**AGENDA**  
**PLANNING & ZONING COMMISSION SPECIAL MEETING**  
**TUESDAY, JULY 26, 2022 - 3:30 PM**  
**McAllen Development Center, 311 N. 15<sup>th</sup> Street, McAllen, Texas**  
**EXECUTIVE CONFERENCE ROOM, PLANNING DEPARTMENT**

**Memo**

**TO:** Planning and Zoning Commission  
**FROM:** Planning Staff  
**DATE:** July 11, 2022  
**SUBJECT:** **SITE PLAN APPROVAL FOR LOT 10, CITRUS GROVE PLAZA PHASE 1-A, LOT 10. 4129 EXPRESSWAY 83. (SPR2022-0036)**

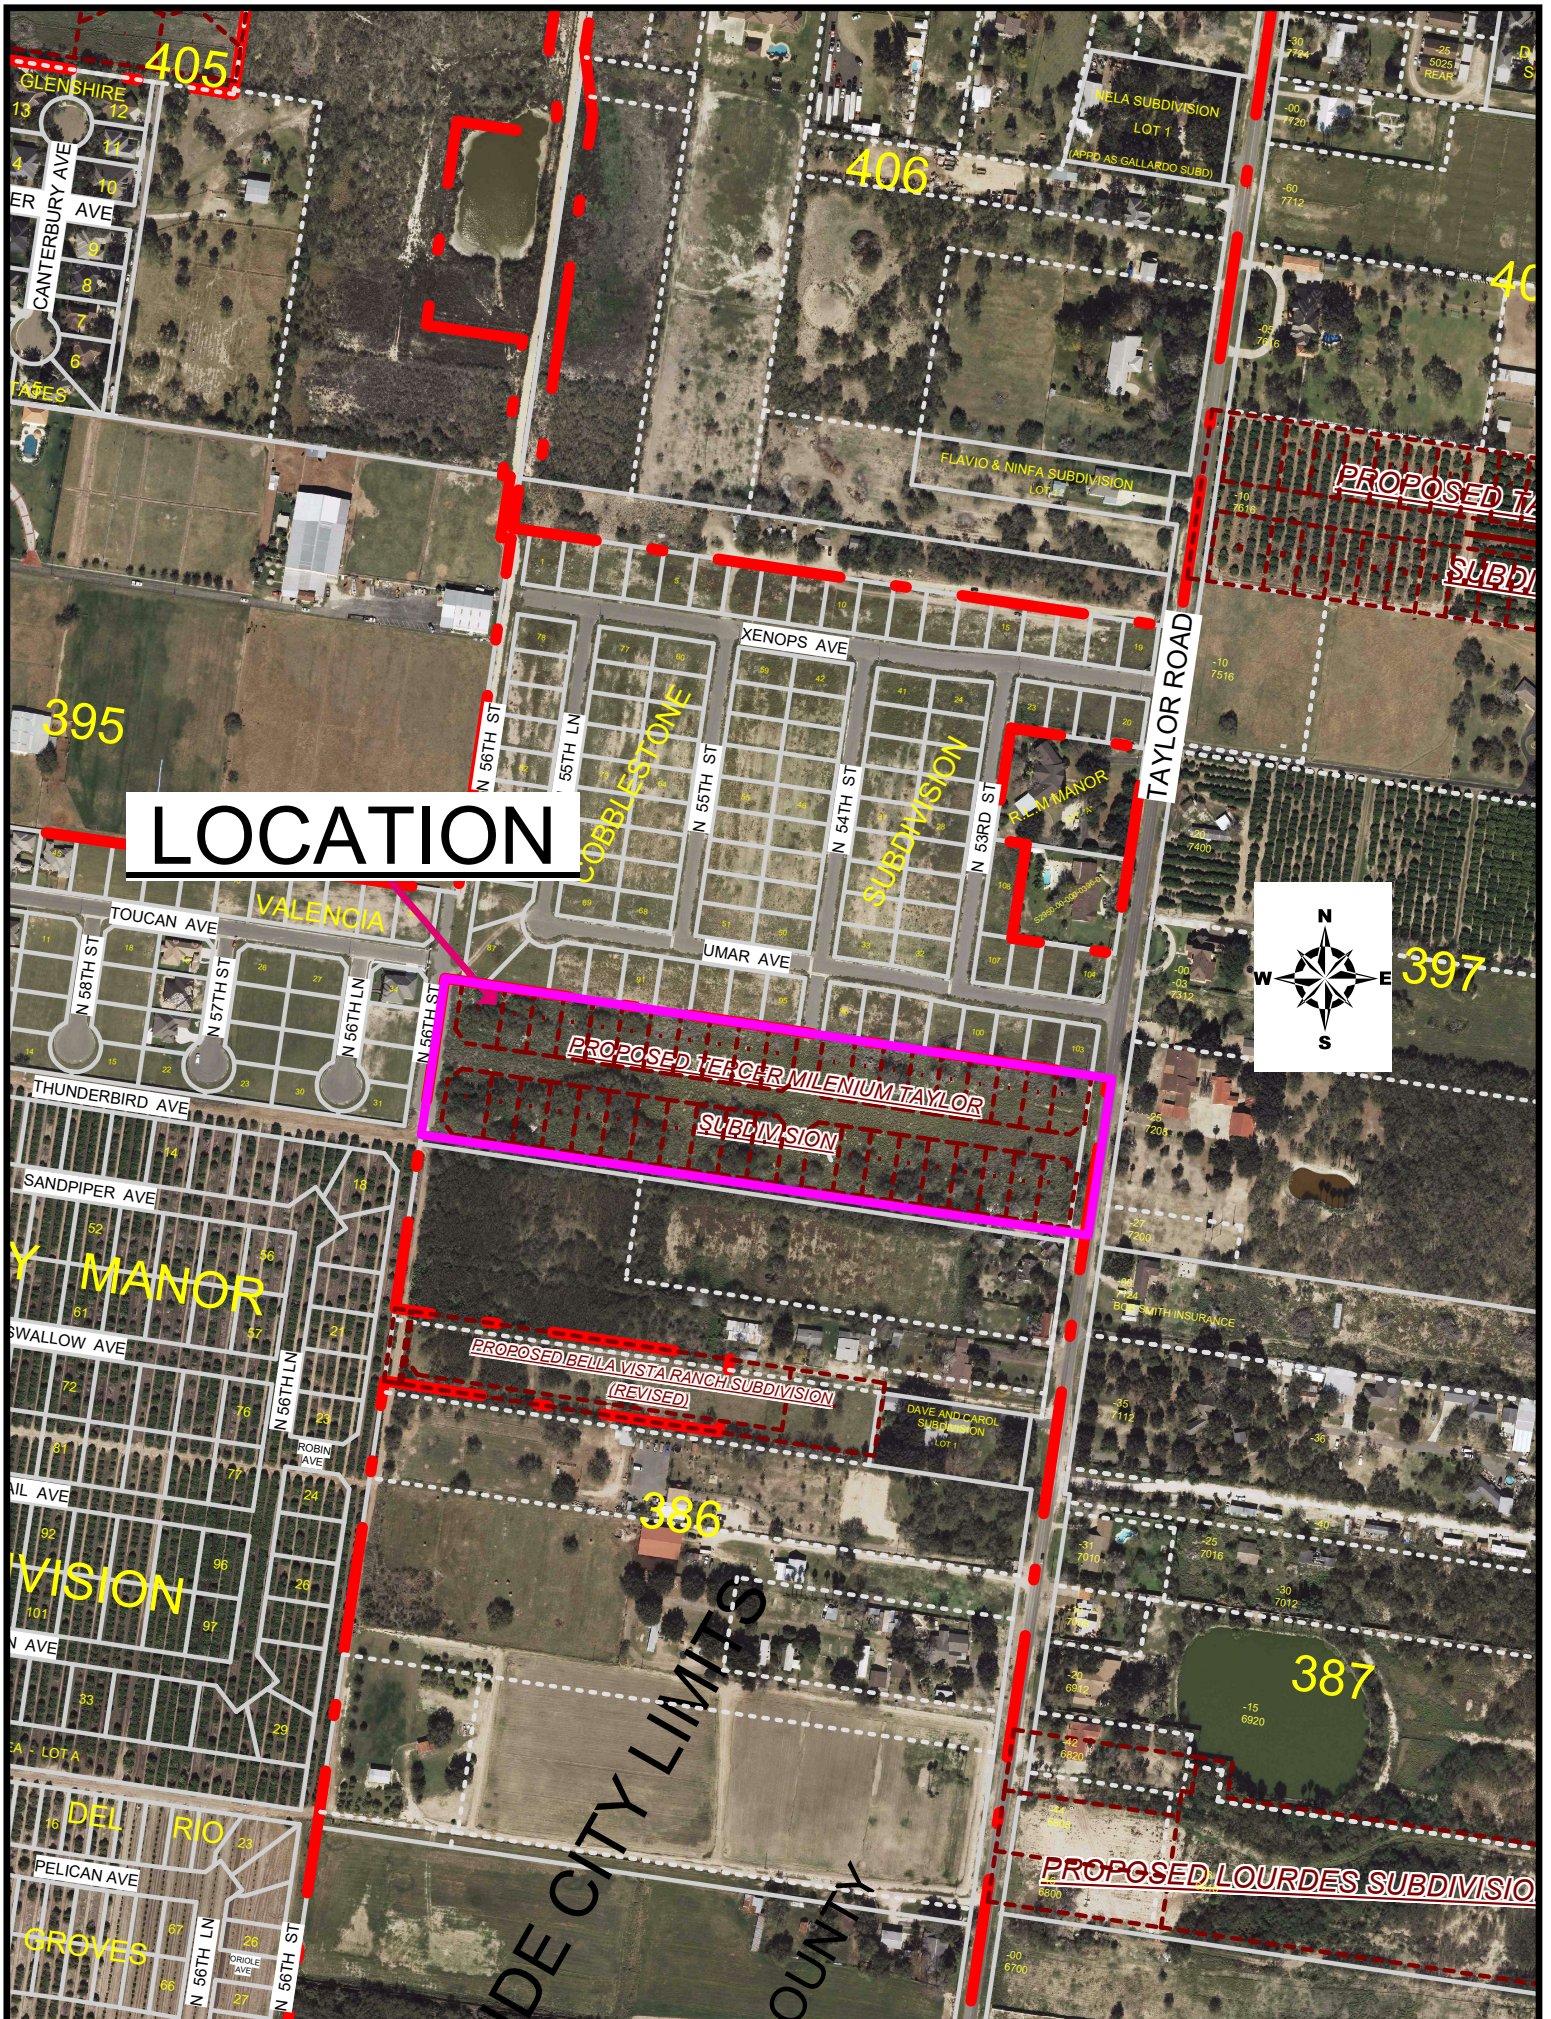
<b>NOTES</b>	
<ul style="list-style-type: none"> <li>* No curb cut, access, or lot frontage permitted along N. Taylor Rd., Thunderbird Ave., and N. 56th St.</li> <li>***Please revise plat note #9 as shown above prior to final.</li> <li>**Must comply with City Access Management Policy</li> </ul>	Non-compliance
<ul style="list-style-type: none"> <li>* Site plan must be approved by the Planning and Development Departments prior to building permit issuance.</li> </ul>	NA
<ul style="list-style-type: none"> <li>* Common Areas, any private streets/drives, gate areas, etc. must be maintained by the lot owners and not the City of McAllen.</li> </ul>	Required
<ul style="list-style-type: none"> <li>* Common Areas for commercial developments provide for common parking, access, setbacks, landscaping, etc.</li> </ul>	NA
<ul style="list-style-type: none"> <li>* Developer/Homeowner's Association/Owner, their successors and assignees, and not the City of McAllen shall be responsible for compliance of installation and maintenance and other requirements per Section 134-168 of the Subdivision Ordinance, including but not limited to common areas and its private streets.</li> <li>**Section 110-72 applies if private subdivision is proposed.</li> <li>**Landscaping Ordinance: Section 110-72</li> <li>**Subdivision Ordinance: Section 134-168</li> </ul>	Required

<ul style="list-style-type: none"> <li>* Homeowner's Association Covenants must be recorded and submitted with document number on the plat, prior to recording.</li> <li>**Section 110-72 applies if private subdivision is proposed.</li> <li>**Landscaping Ordinance: Section 110-72</li> <li>**Subdivision Ordinance: Section 134-168</li> </ul>	Required
<b>LOT REQUIREMENTS</b>	
<ul style="list-style-type: none"> <li>* Lots fronting public streets</li> <li>**Subdivision Ordinance: Section 134-1</li> </ul>	Compliance
<ul style="list-style-type: none"> <li>* Minimum lot width and lot area</li> <li>**Zoning Ordinance: Section 138-356</li> </ul>	Compliance
<b>ZONING/CUP</b>	
<ul style="list-style-type: none"> <li>* Existing: ETJ Proposed: Residential</li> <li>****Rezoning Needed Before Final Approval if annexed with initial zoning reflecting the proposed use.</li> <li>****Rezoning to R-1 needed if annexed for single family use.</li> <li>***Zoning Ordinance: Article V</li> </ul>	TBD
